City of Evansville **Plan Commission**
Regular Meeting
Tuesday, August 4, 2020, 6:00 p.m.

5. Civility Reminder
6. Citizen appearances other than agenda items listed
7. New Business
 - A. Discussion and Public Hearing of Preliminary Land Division Application LD-2020-02 to create Settler's Grove Subdivision on Porter Road.

RE: Staff Comments

Subject: Settler's Grove – Preliminary Plat Review

RANCH VIEW ESTATES
WATER PRESSURE SERVICE COMPARISONS

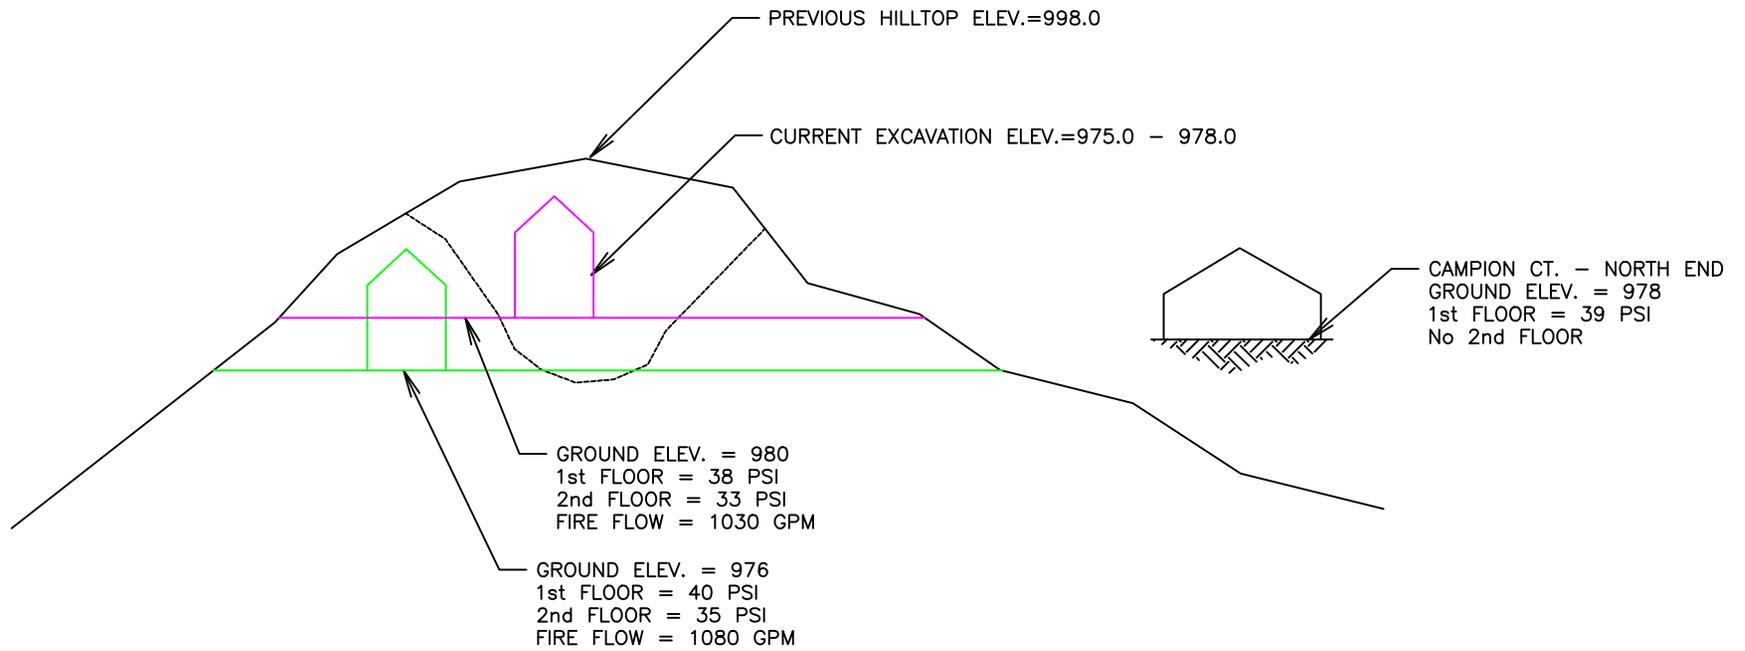
It was requested the City look into the possibility of using a water booster to supply acceptable water pressure to the higher elevations of the Ranch View Development. The City met with the developer and Baker Manufacturing to discuss the possibility of a sub-surface pump. After further discussion the City has several concerns including: accessibility during a failure event, the ability to monitor such a device versus the use of a traditional above ground station and SCADA system integration. Brian Berquist also met with several other municipalities that have similar sub surface boosters, none of which are currently being used as a permanent solution.

The City has come up with its own non-mechanical solution. We recommend reducing the elevation of the “knob” of the development. The below is a calculation of pressure for the following final elevations:

Ground Elevation 980	Ground Elevation 976
1 st Floor = 38 PSI	1 st Floor = 40 PSI
2 nd Floor = 33 PSI	2 nd Floor = 35 PSI
Fire Flow + 1030 GPM	Fire Flow = 1080

At elevation 980 it would give adequate pressure to single story homes as well as adequate fire protection based on DNR & ISO Standards. If a two story home is desired the use of an in home booster can be used at a relatively low cost.

The developer also has the ability to keep the spoils on site adding an approximate 6 inch rise in elevation to the remaining portion of the development. There is also the possibility for using some of the earth to form a raised multimodal pathway as well as additional park land.

At present, based on the information we have to date, the City is not interested in accepting an additional asset for an issue which can be resolved without mechanical means.
